FINAL PLAT
GRANDVIEW COUNTRY ADDITION
SEDGWICK COUNTY, KANSAS
2002

RE: SUB 2001-86 -- Final Plat of Grandview Country Addition

CASE NUMBER: SUB 2001-86 -- GRANDVIEW COUNTRY ADDITION

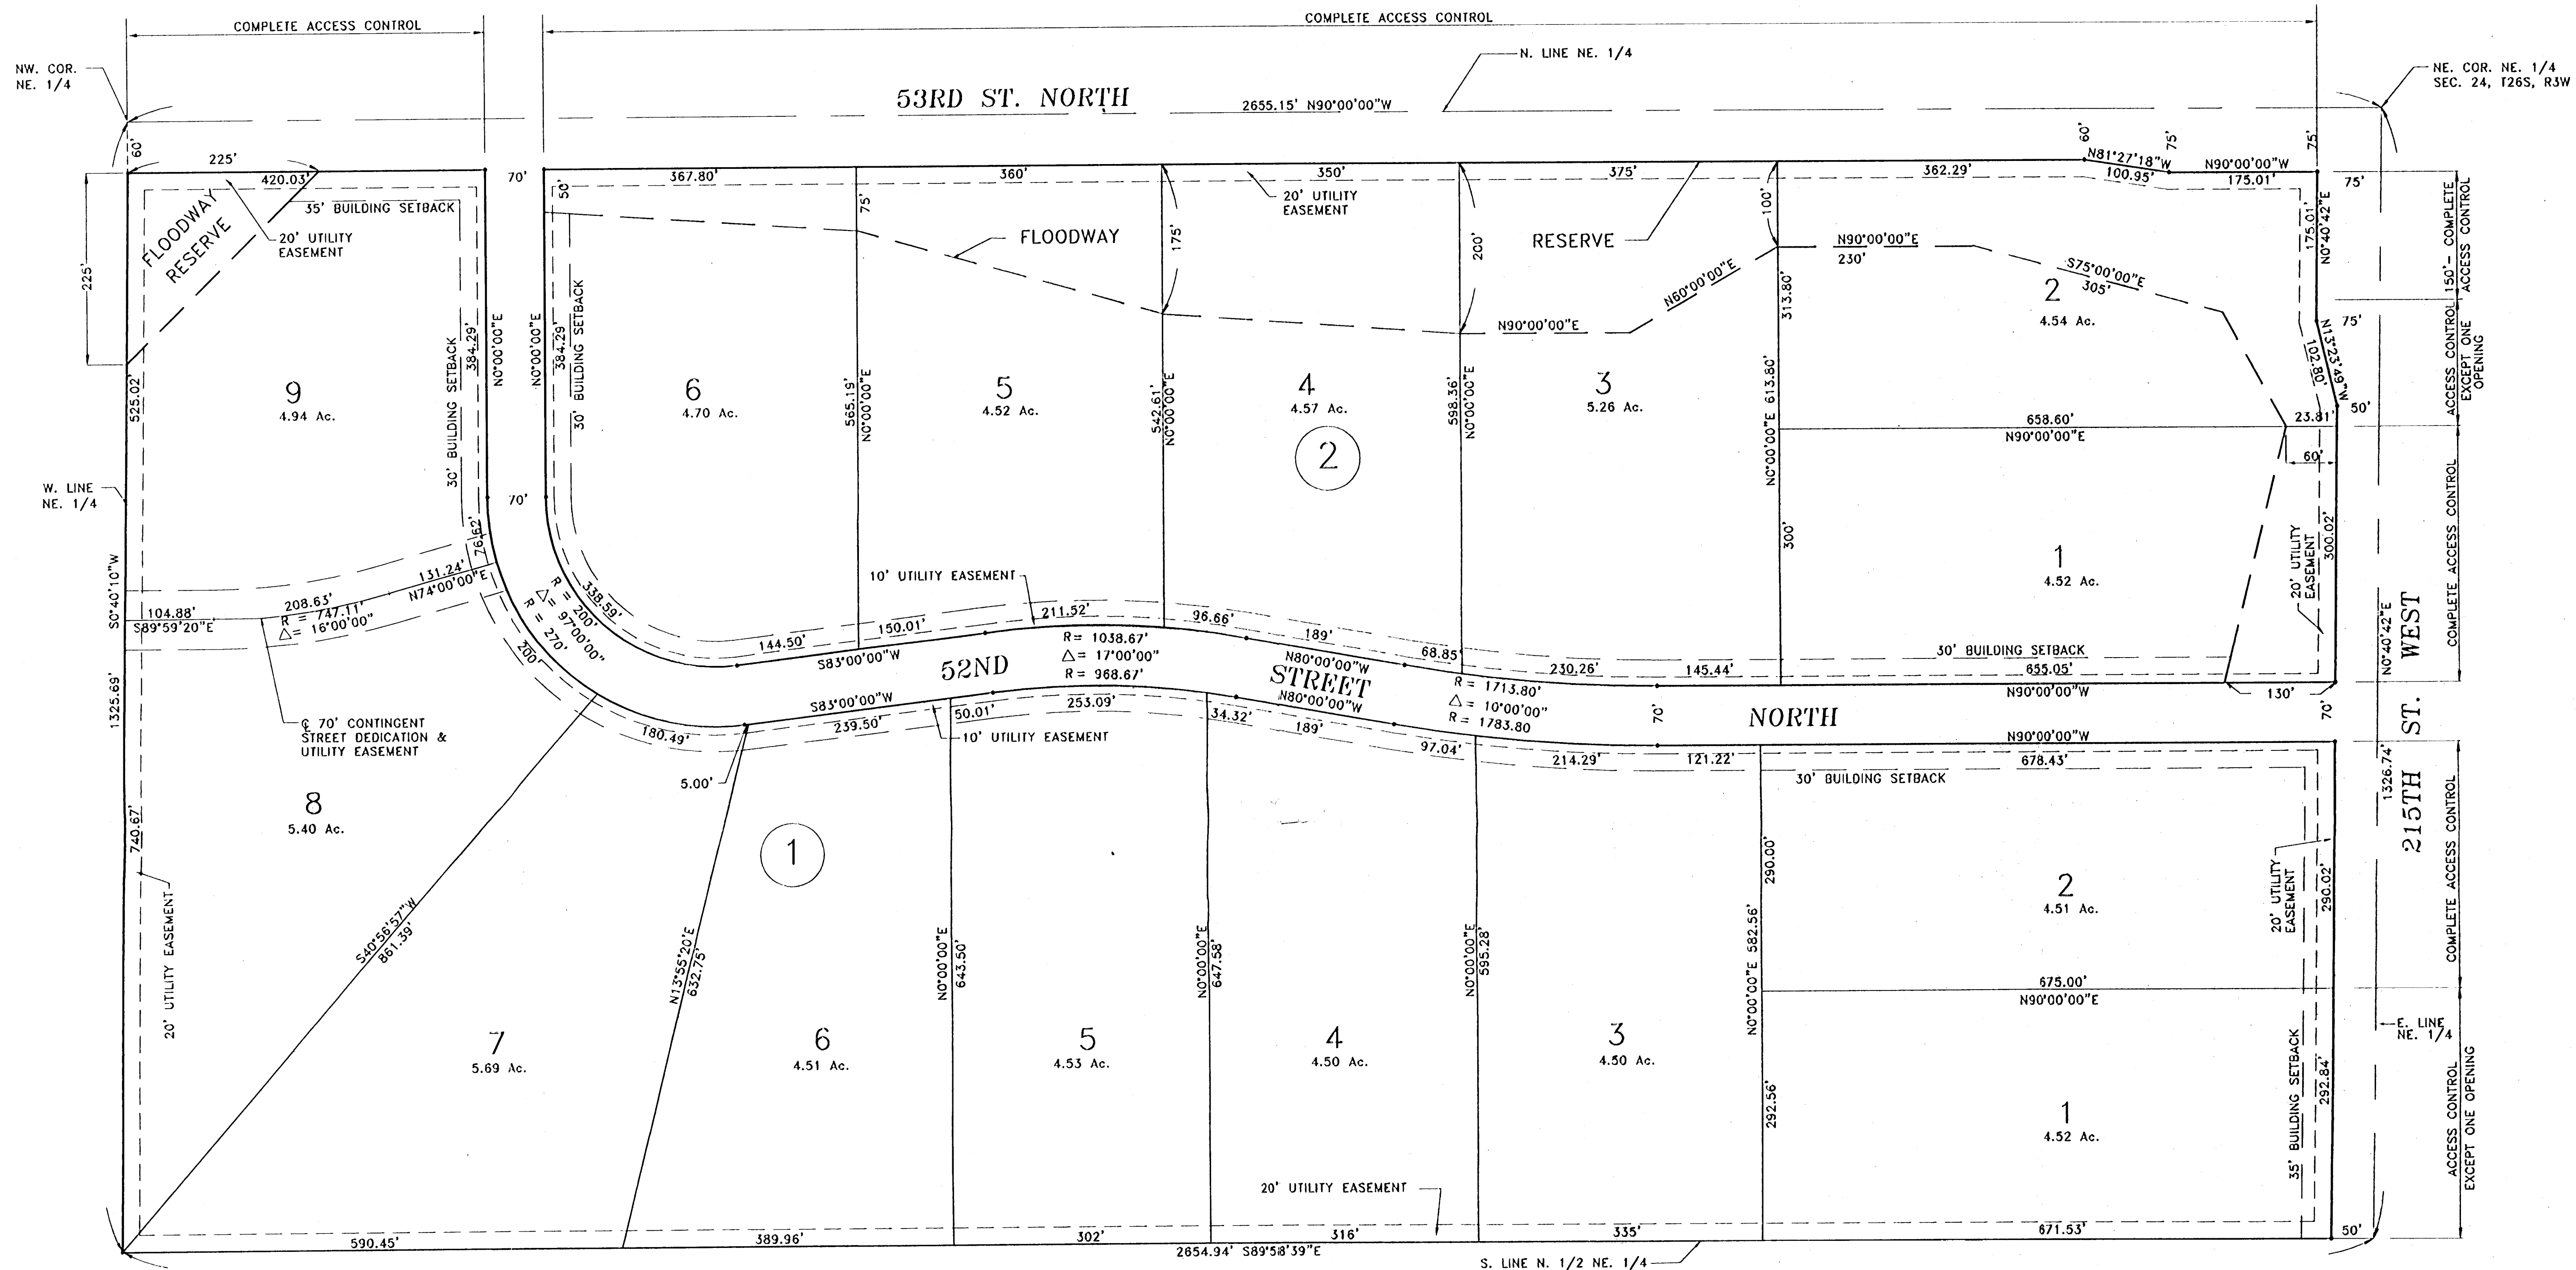
- C. County Engineering needs to comment on the status of the applicant's drainage plan. *A road profile is required on 53rd St. to determine back water elevations in floodway reserves. An additional drainage easement is required between Lots 8 and 9 of Block 1. A final lot grading plan is needed.*

- D. Complete access control has been platted along 215th St. West for Lot 1, Block 2 and Lot 2, Block 1. *A private drive may be constructed within the right-of-way for Lot 1, Block 2, and Lot 2, Block 1. The private drive shall be removed upon the construction of 52nd Street North.*

- H. Approval of this plat will require a waiver of the lot depth to width ratio of the Subdivision Regulations for Lots 7 and 8, Block 1. The Subdivision Regulations state that the maximum depth of all residential lots shall not exceed 2.5 times the width. The Subdivision Committee has approved a modification.

- C. **County Engineering** needs to comment on the status of the applicant's drainage plan. **A road profile is required on 53rd St. to determine back water elevations in floodway reserves. An additional drainage easement is required between Lots 8 and 9 of Block 1. A final lot grading plan is needed.**

- D. Complete access control has been platted along 215th St. West for Lot 1, Block 2 and Lot 2, Block 1. **A private drive may be constructed within the right-of-way for Lot 1, Block 2, and Lot 2, Block 1. The private drive shall be removed upon the construction of 52nd Street North.**

- H. Approval of this plat will require a waiver of the lot depth to width ratio of the Subdivision Regulations for Lots 7 and 8, Block 1. The Subdivision Regulations state that the maximum depth of all residential lots shall not exceed 2.5 times the width. **The Subdivision Committee has approved a modification.**

- S. The representatives from the utility companies should be prepared to comment on the need for any additional utility easements to be platted on this property. **The Subdivision Committee has required a 20-ft perimeter utility easement along the rear of the lots.**
